# UNITED STATES PATENT AND TRADEMARK OFFICE

10/803,201

Leonid Shmaenok

| <b>Office Action Summary</b> | <b>Application No.</b><br>10/803,201 | <b>Applicant(s)</b><br>SHMAENOK, LEONID |  |

**FIG. 1**

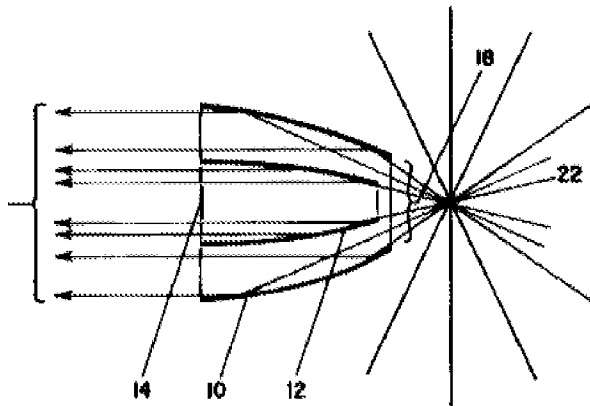
5. Claims 1 and 3 are rejected under 35 U.S.C. 102(b) as being anticipated by O'Hara (US Patent 5,768,339).

With respect to claim 1, O'Hara teaches an apparatus (Figs. 1 and 2 A-B) comprising a radiation source (22) and a processing organ for processing radiation from the radiation source, wherein a filter for suppressing undesired atomic and microscopic particles is placed between the radiation source and the processing organ, which filter

comprises a plurality of foils or plates having surfaces for trapping atomic and microscopic particles thereon, wherein each foil or plate essentially points in a radial direction when viewed from the radiation source (see abstract).

**FIG. 2a**

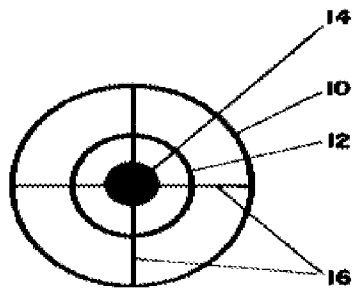
With respect to claim 3, Hase teaches that the foils or plates are coneshaped and are positioned concentrically (Fig. 2A).

Claim limitations that employ phrase “for doing something” and specifically with respect to claim 1 “for trapping atomic and microscopic particles thereon” is a typical of claim limitations which may not distinguish over the prior art. It has been held that recitation that an element is for doing something is not a positive limitation but only requires the ability to so perform. It has been held that a recitation with respect to the manner in which a claimed apparatus is intended to be employed does not differentiate the claimed apparatus from a prior art apparatus satisfying the claimed structural limitations. In this case O’Hara et al. clearly teaches all of the structural limitations that are claimed in claims 1 and 3.
